VILLAGE OF GERMANTOWN
N112 W17001 MEQUON ROAD, GERMANTOWN, WI 53022

MEETING:	PLAN COMMISSION
DATE AND TIME:	MONDAY, JULY 13, 2020 6:30 p.m.
LOCATION:	Germantown Village Hall Board Room N112 W17001 Mequon Road

7/13/20 Plan Commission Meeting

Village Planner Report

R-1 Road A – Roadway and Storm Sewer

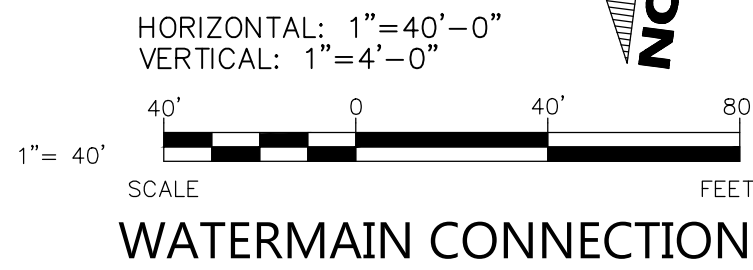
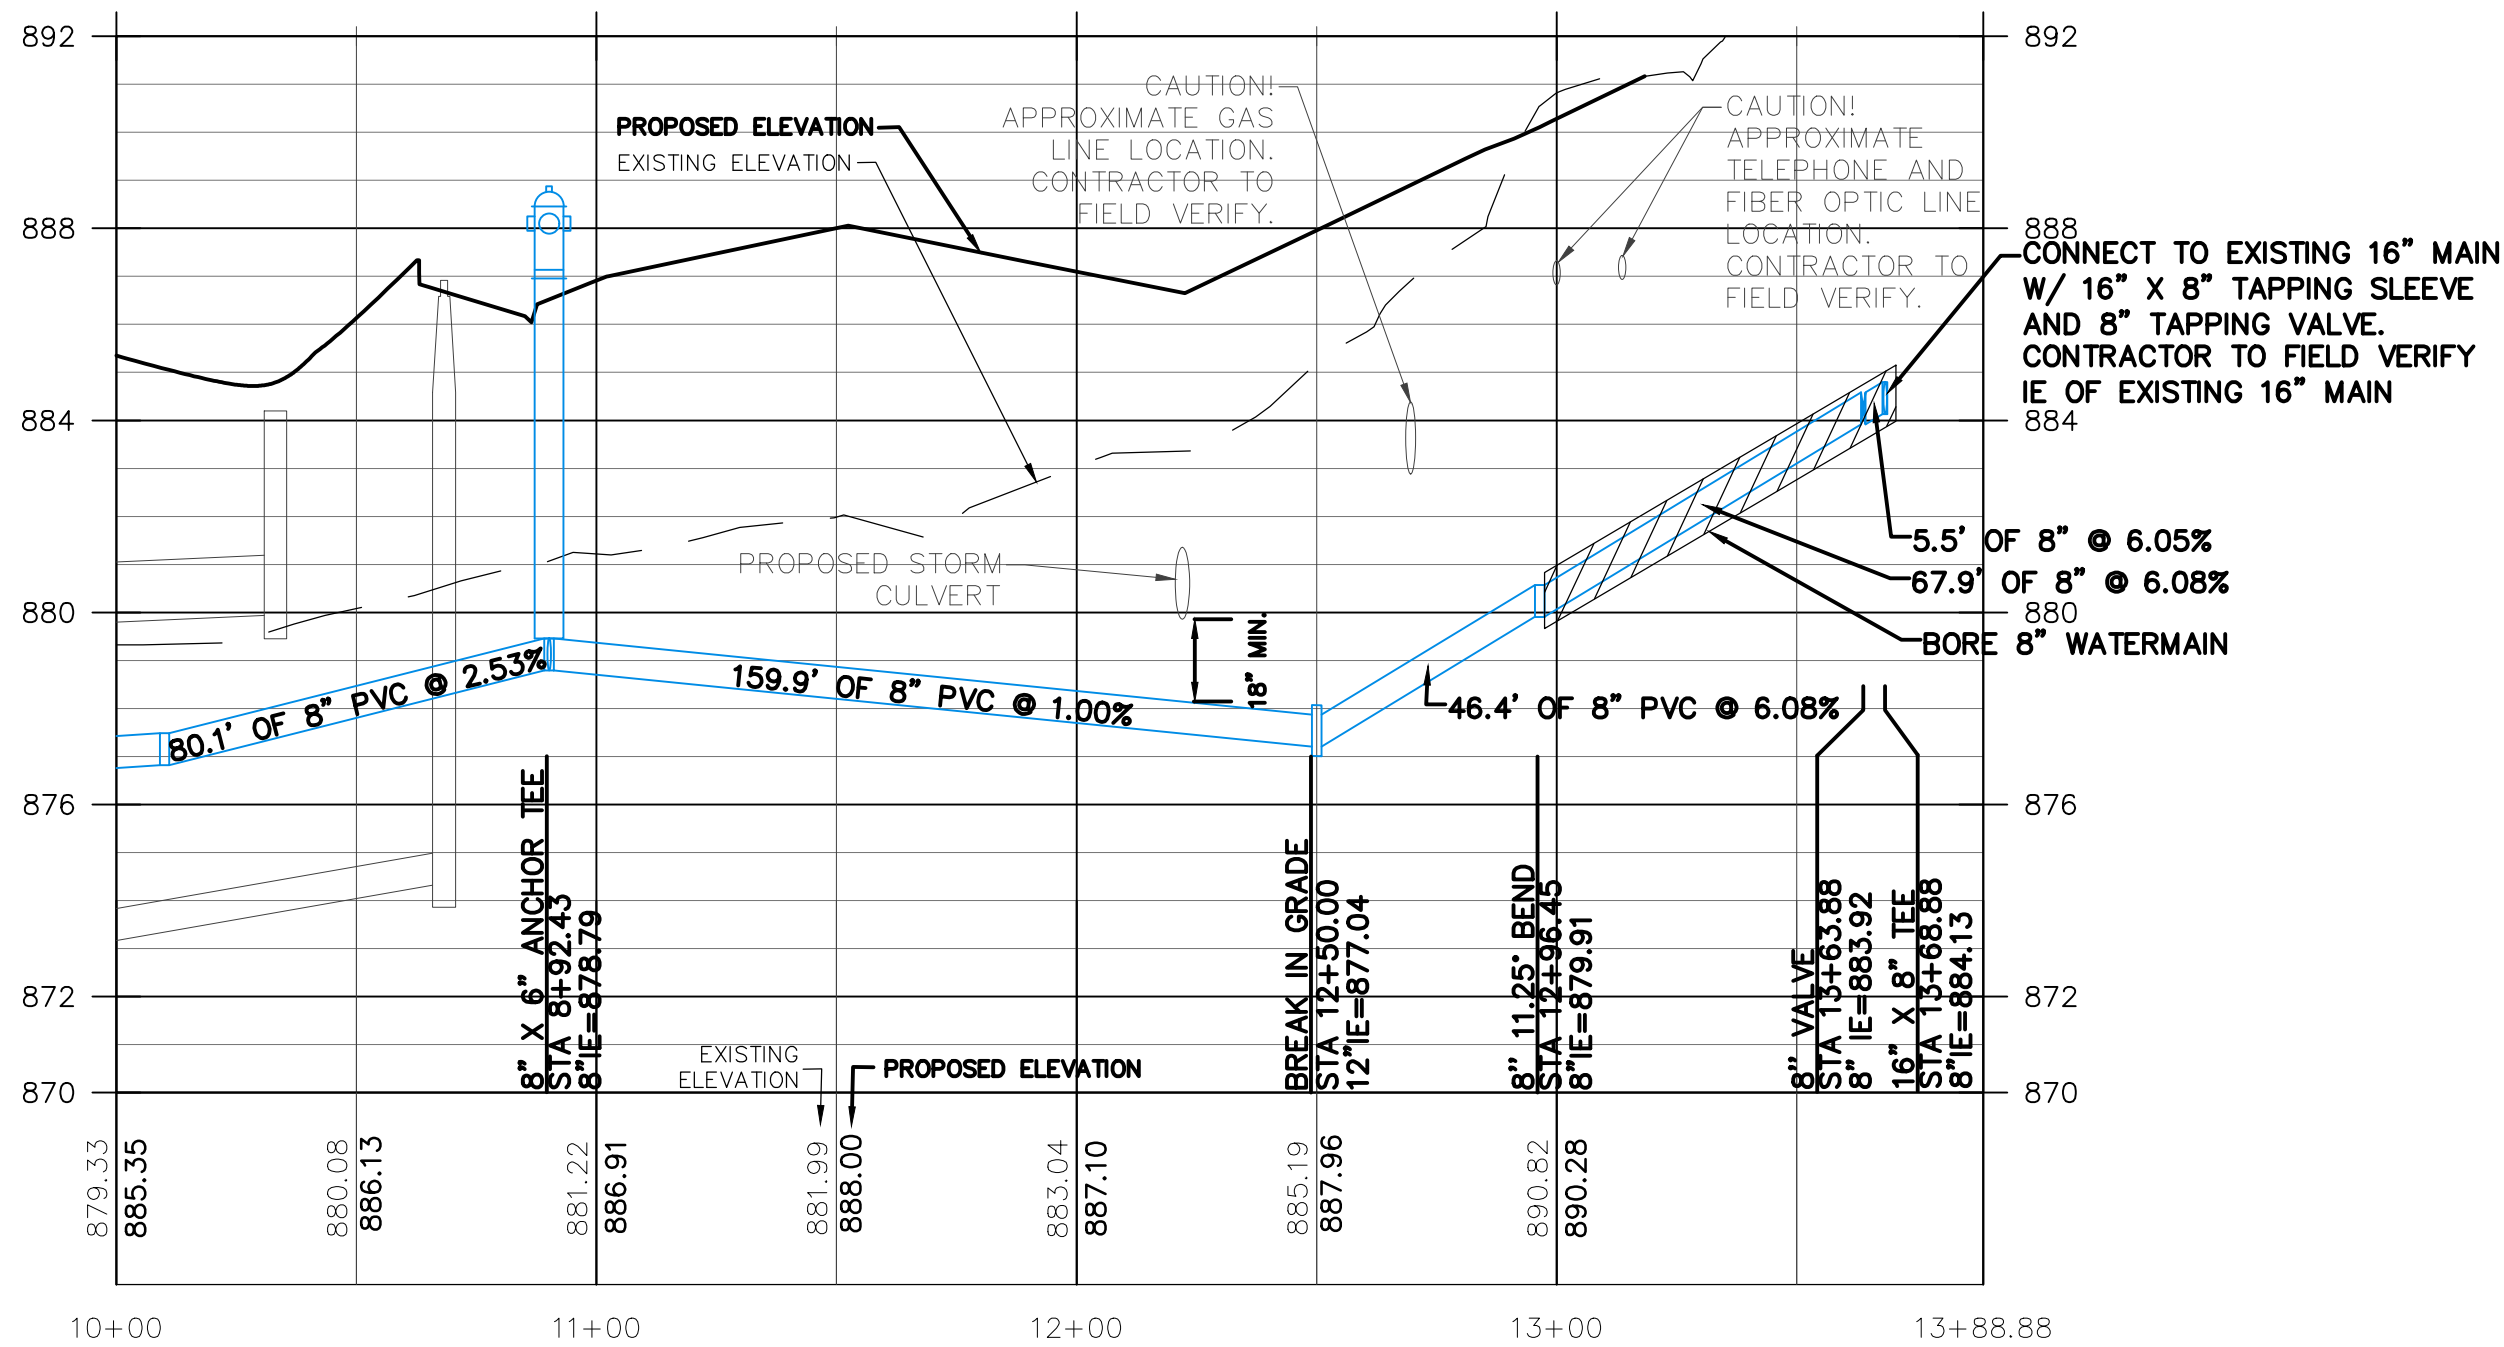
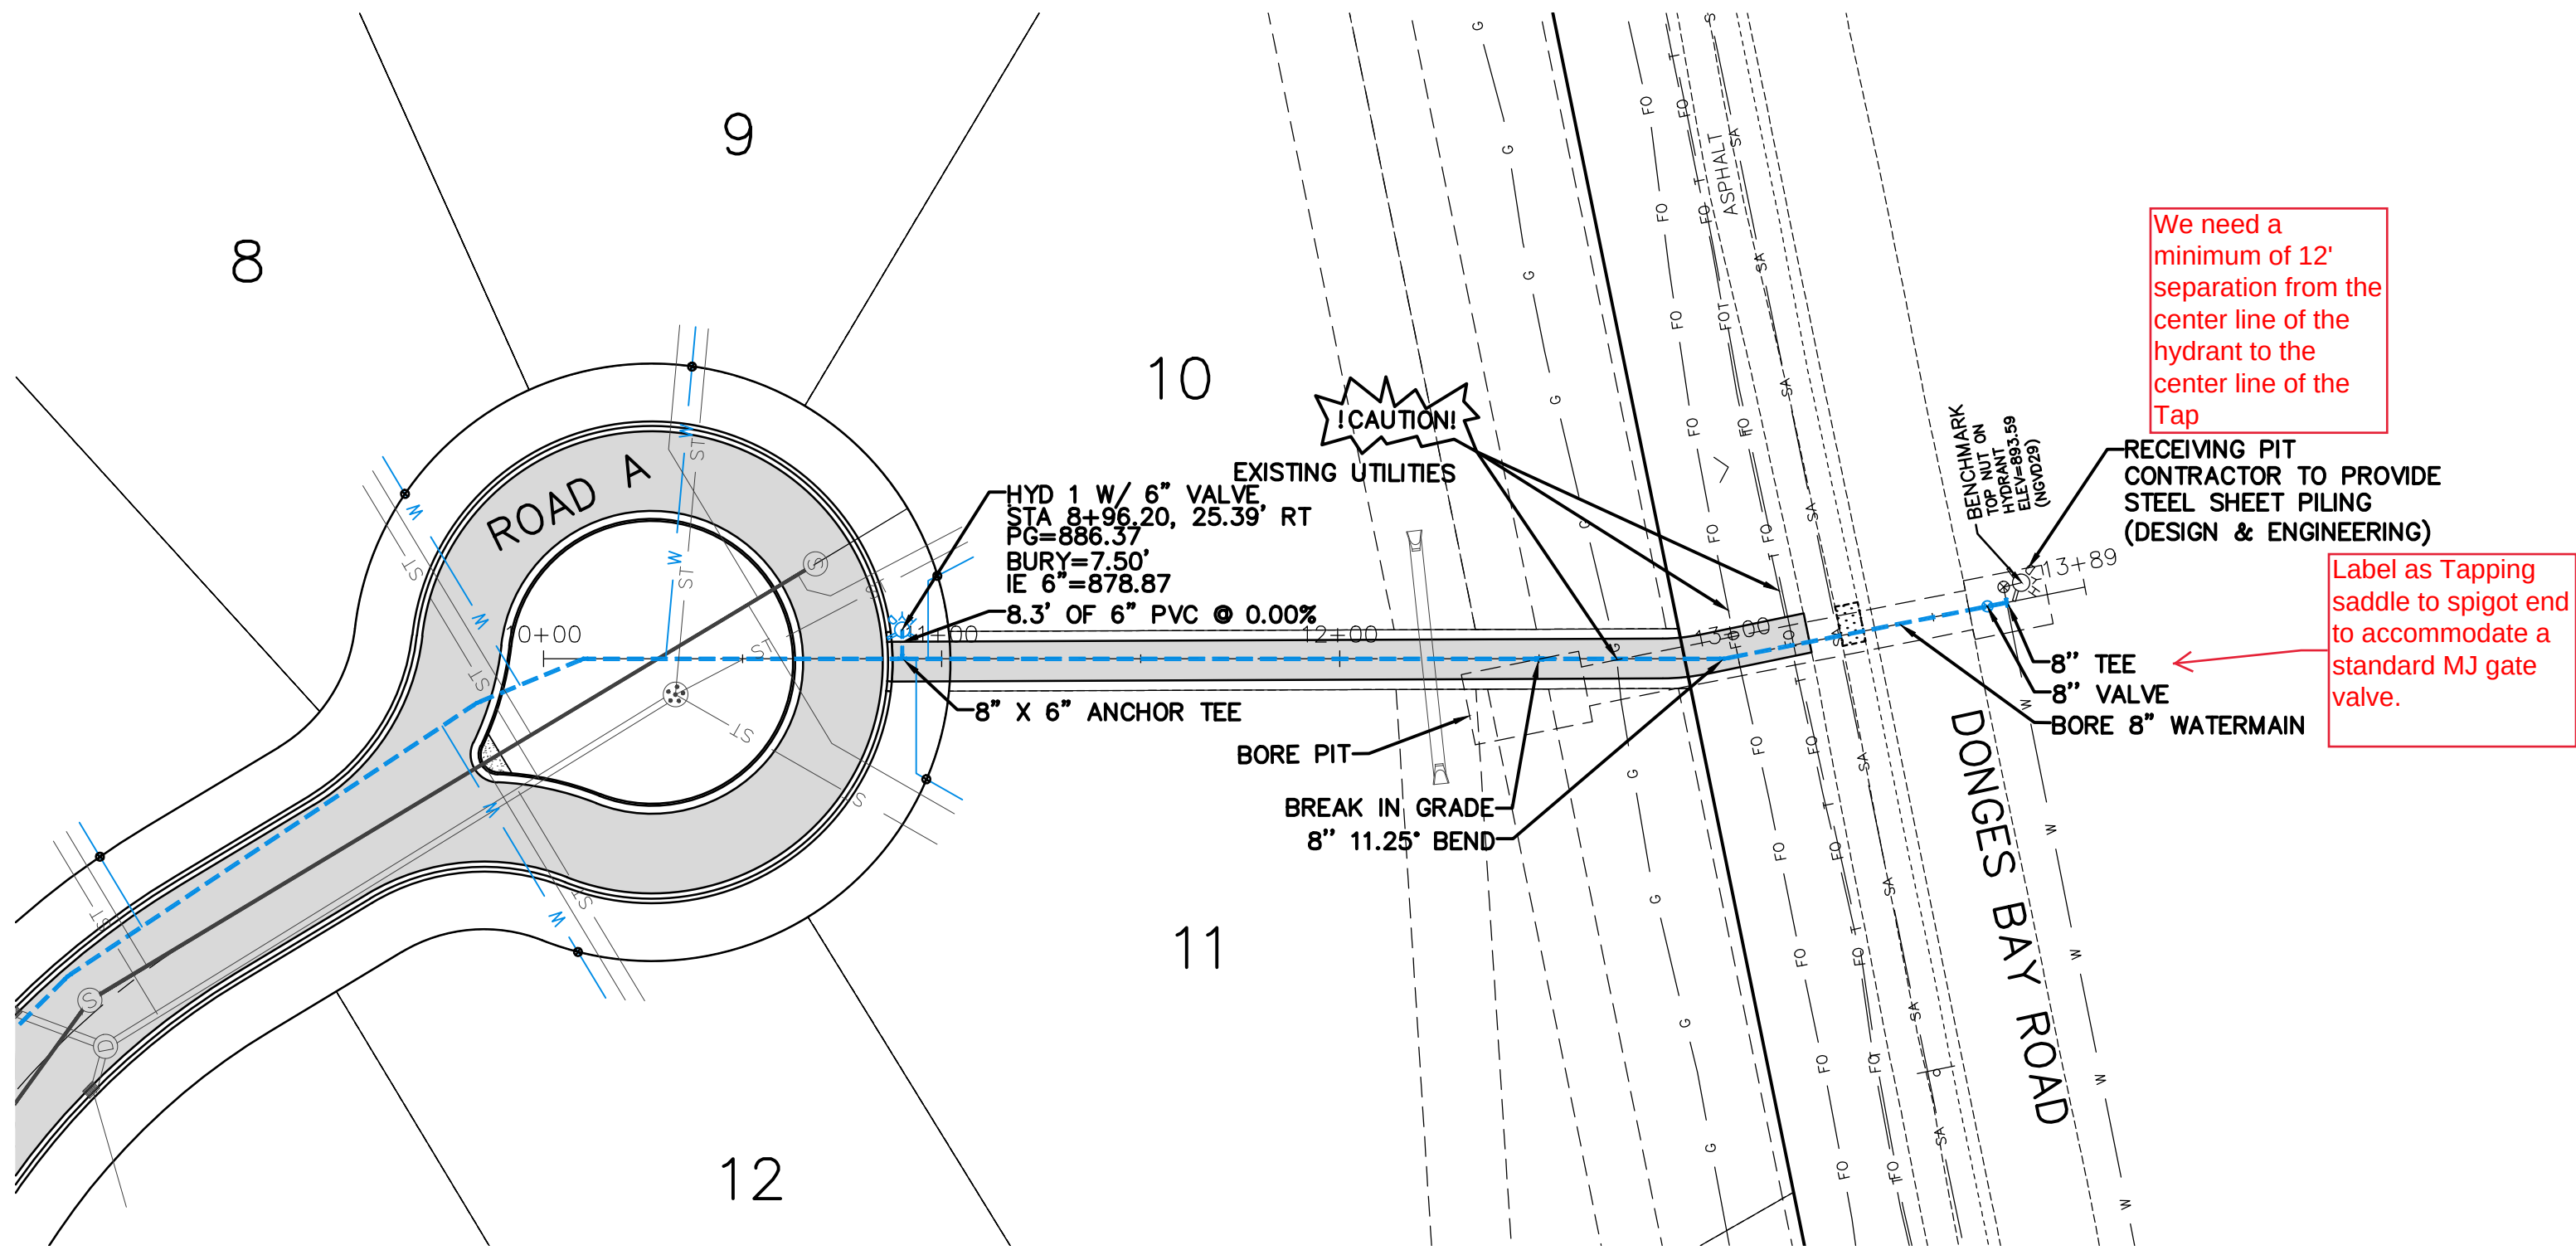
- 1 Add vertical curves to the grade breaks at stations 2+02 and 6+58
2. Village standards require 3' minimum cover. Revise manhole 1 to meet this requirement.

LANDSCAPE PLAN

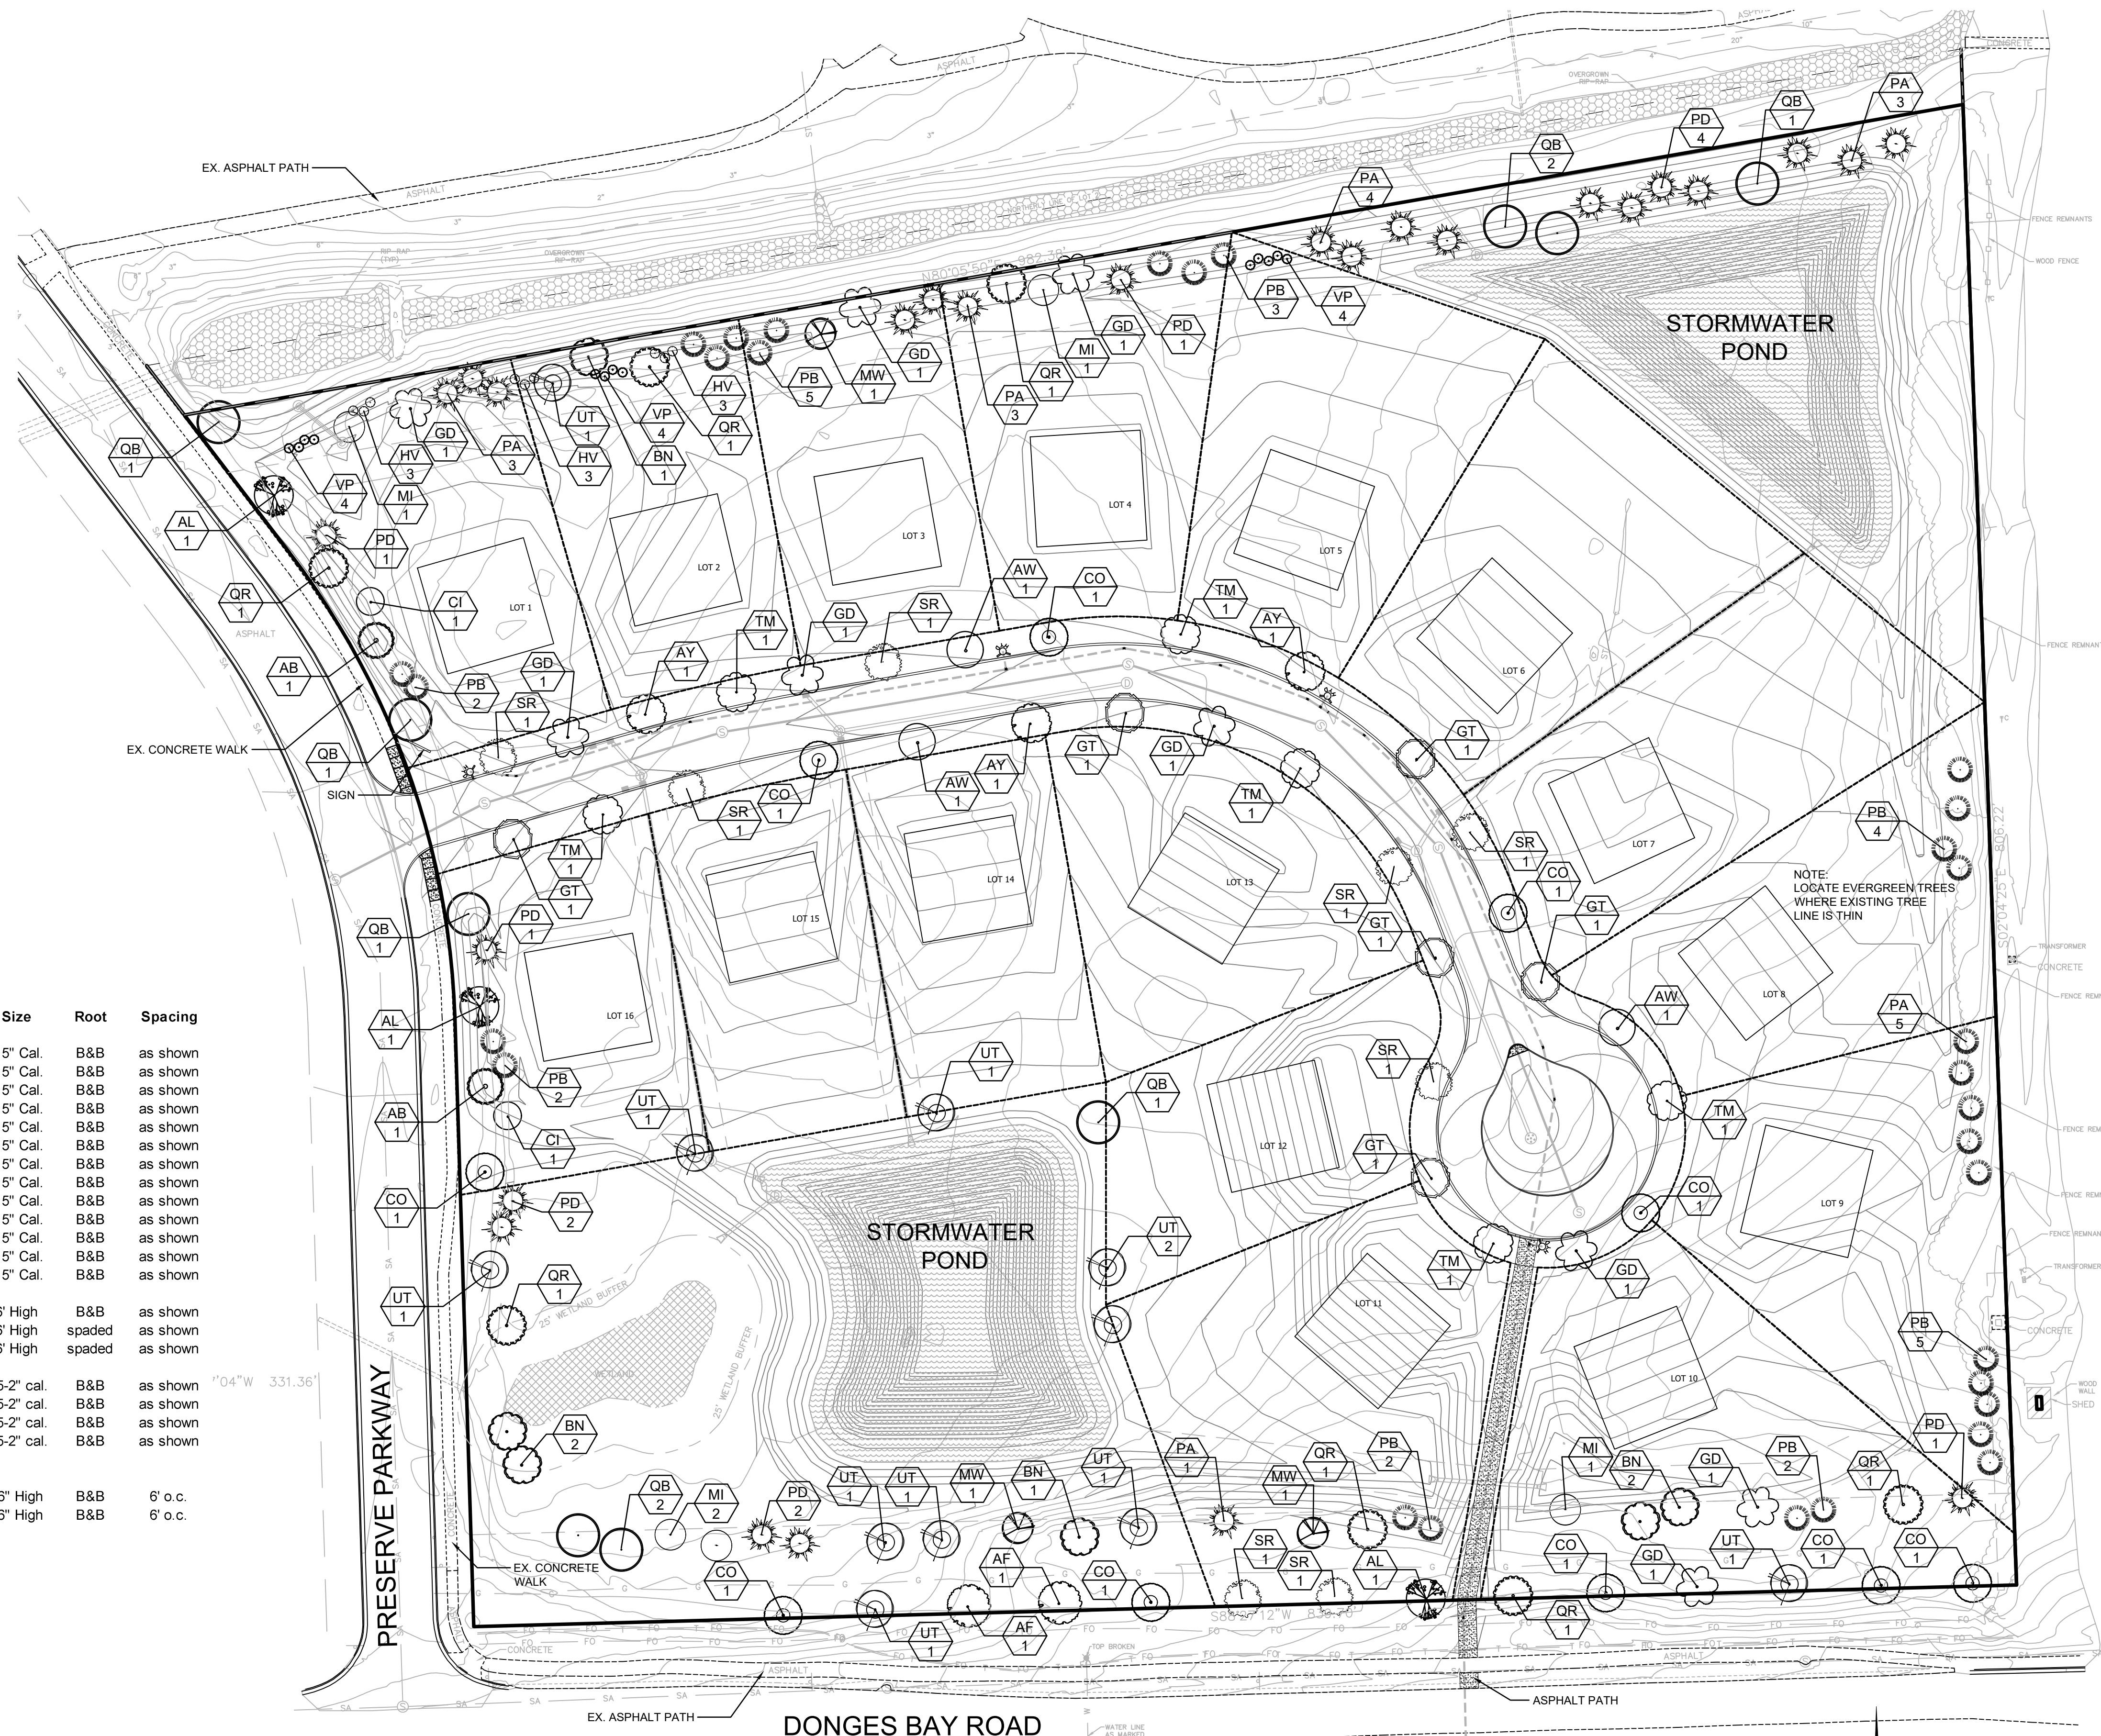
As required by the Plan Commission as part of the rezoning and concept plan approval, the Developer has submitted a street tree and landscaping plan for the common areas. Staff is concerned that the landscape plan is inadequate. In the landscape plan, the presentation shows trees at full growth and, as such, gives the appearance of there being more than enough trees to provide the desired buffering (when there really isn't enough since the planted size will be significantly smaller than at mature growth). Also, the way the plan is prepared, i.e. where the placement and shape of the species “call out” labels is co-mingled with the actual tree, it gives the appearance of more trees than there actually will be. For this reason, the plan looks sparse in terms of total quantity and especially evergreen trees for a plan that is supposed to be “heavy” on landscaping for visual buffering purposes.

Also, at the time the rezoning & concept plan were approved, the Plan Commission required landscape/buffering along the rear yard property lines of the lots around the Southwest storm basin in Outlot 3, but the proposal is to install landscaping in the open space area. While the Village does not have a prescribed standard or minimum design requirement for buffer areas, it is expected that such areas will include a combination of high-density deciduous and evergreen trees and shrubs (50/50%) along the side slopes of undulating berms. No berming is proposed in the plan and the number and type of trees does not appear to provide an acceptable level of visual buffering. Consequently, staff is recommending additional landscaping be installed in the following areas:

- Backs of Lots #12, #13, #14, #15 & #16
- Adjacent to the 15' vision corners at the road entrance on Lot #1 & #16
- The landscaping plan should include landscaping around the entrance sign and in the cul-de-sac island

2. The Developer shall submit a revised street tree and landscaping plan for the common area improvements to the Village Planner and Village Forester for final review and approval prior to or concurrent with execution of a Development Agreement with the Village. Said revised plan shall contain additional landscaping as follows: (a) along rear property lines and/or in the outlot area abutting Lots #12, #13, #14, #15 & #16; (b) adjacent to the 15' vision corners at the road entrance on Lot #1 & #16; (c) around the entrance sign and in the cul-de-sac island; (d) additional landscaping needs to be added to help provide a buffer for the adjacent Heritage Hills subdivision along the rear property lines or in the outlot area abutting Lots #5, 6, and 7.
